Access Compliance Report

Public Rights-of-Way

(Curb Ramps)

Intersection ID: 43676	Main Street: SARDIS_COMMONS_LN	Cross Street: SARDIS_RD	Location: NW
ADA ID: 8F5236C15453	Ramp Type: Perpendicular Diagonal	Initial Pass/Fail: Fail	Overall Compliance: No Severity Score: 21.25

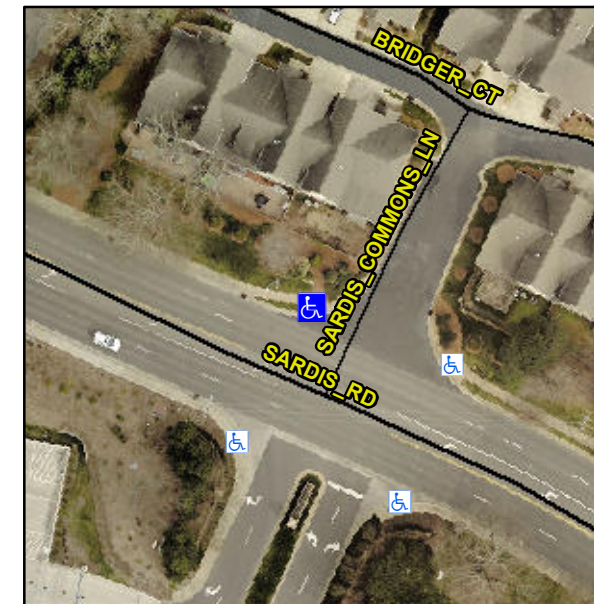
Not Found, R304.5.1, R304.2.2

Compliance	Description	Data	Compliance	Description	Data
N/A	Ramp Length (in)	48.5	No	Ramp Slope (%)	10.9
No	Ramp Width (in)	45.5	Yes	Ramp XSlope (%)	0.9
N/A	Flare Type LT	N/A	N/A	Flare Type RT	N/A
N/A	Flare Slope LT (%)	N/A	N/A	Flare Slope RT (%)	N/A
N/A	Flare Traversable LT?	N/A	N/A	Flare Traversable RT?	N/A
N/A	Landing Length (in)	N/A	N/A	DWS Provided?	N/A
N/A	Landing Width (in)	N/A	N/A	DWS Contrast?	N/A
N/A	Landing Slope (%)	N/A	N/A	DWS Length (in)	N/A
N/A	Landing X Slope (%)	N/A	N/A	DWS Full Width?	N/A
N/A	Landing Curb? (Y/N)	N/A	N/A	DWS Offset (in)	N/A
N/A	Shared Landing?	N/A			
N/A	Gutter Ponding?	N/A	N/A	Gutter Slope (%)	N/A
N/A	Gutter Lip Ht (in)	N/A	N/A	Gutter X Slope (%)	N/A
N/A	Painted X Walk1?	No	N/A	Painted X Walk2?	No
	X Walk 1 Direction	To SW		X Walk 2 Direction	To SE
N/A	X Walk 1 Width (in)	N/A	N/A	X Walk 2 Width (in)	N/A
	X Walk 1 Slope (%)	4.2		X Walk 2 Slope (%)	4.2
	X Walk 1 X Slope (%)	4.3		X Walk 2 X Slope (%)	2.4

Remove & Replace Curb Ramp With Two New Directional Ramps or Equivalent.
